PROJECT  
TENDER NO.  
SUBJECT

: STEAM GENERATION PLANT AT TALCHER, ODISHA  
: PNMM/PC-150/E-4003/NCB  
: REPLY TO PRE-BID QUERIES : LOT 4 Dated 30.7.2020

CLIENT : M/s. TALCHER FERTILIZER LIMITED  
 LOCATION : TALCHER, ANGUL DISTRICT, ODISHA(INDIA)  
 TITLE : PLOT PLAN OF PROPOSED INTEGRATED COAL BASED FERTILIZER AND CHEMICALS COMPLEX

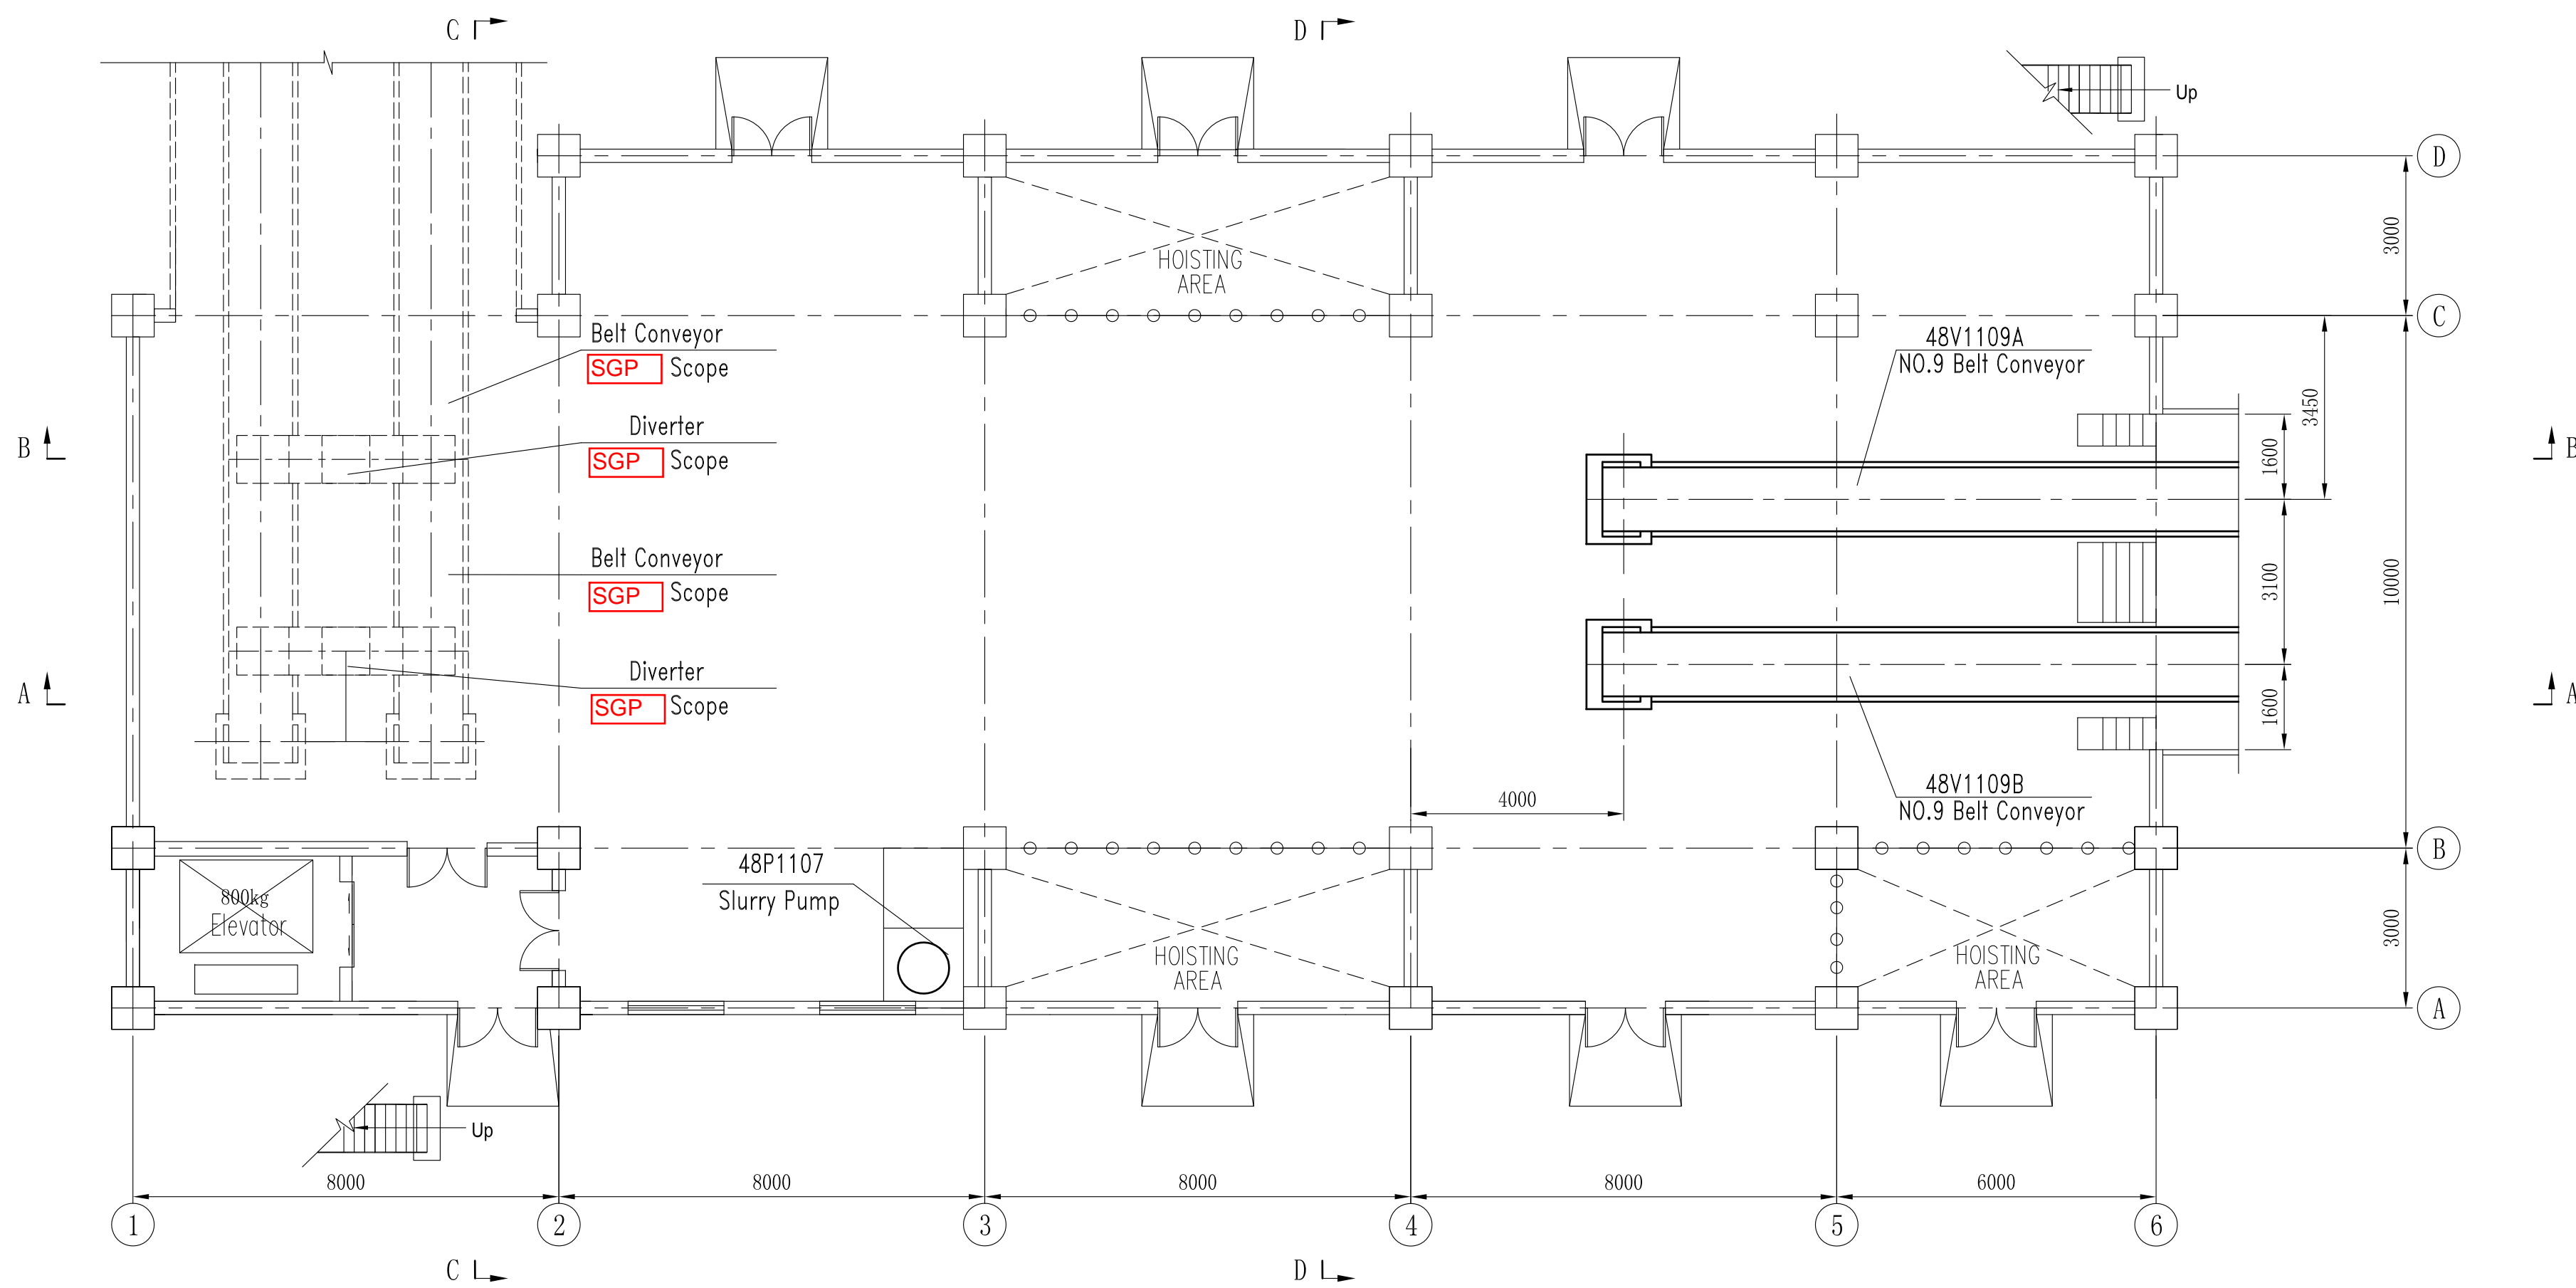
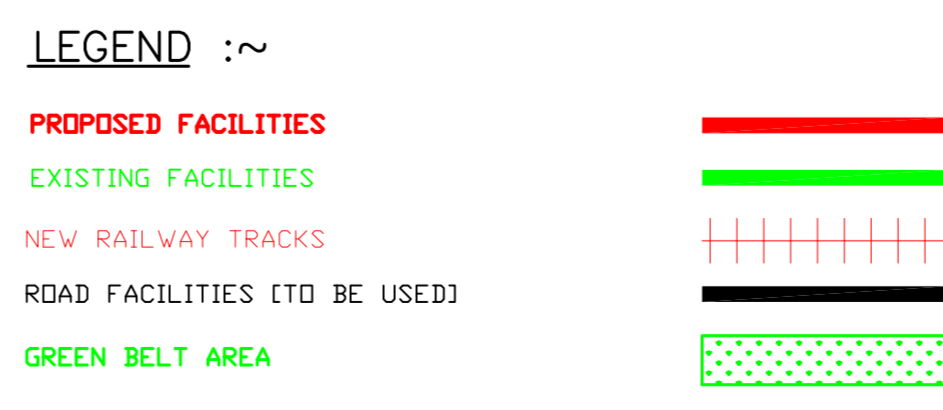
29.	REPLY TO PRE-BID QUERIES : TECHNICAL – LOT 1		188	BIDDER'S QUERY - 1) Please furnish location of bed ash and fly ash silos. 2) Ash/slag pond is shown in the drawing. However, the same is not applicable.	As ash/slag pond is a large area, please specify the exact location of silos as the same will affect the conveying distance and thus the compressor capacity  Please refer attached Plot Plan.

Sl. No.	Reference of Tender Document			Bidder's Query	PDIL/TFL's Reply	
	Section No.	Page No.	Clause No.			Subject
				Please confirm. OWNER'S REPLY - Bed ash and fly ash silos in Bidder's scope. Location shall be near Ash/Slag Pond. Ash/slag pond is not in Bidder's scope.

44.	STEAM GENERATION PLANT TALCHER FERTILIZERS LIMITED DESIGN PHILOSOPHY – COAL AND ASH HANDLING SYSTEM	STEAM GENERATION PLANT TALCHER FERTILIZERS LIMITED DESIGN PHILOSOPHY – COAL AND ASH HANDLING SYSTEM pg No 1284 of 2464	LSTK's contractor scope shall be started from Coal Crusher House of Coal Gasification Plant	C	Pls. provide the details at tapping point for coal at battery limit (i.e primary crusher house) We are considering battery limit of coal at the inlet of Belt conveyor which shall start at ground level , that belt conveyor shall feed to secondary crusher house (bidder's scope). Kindly confirm.	Please refer attached Plot Plan
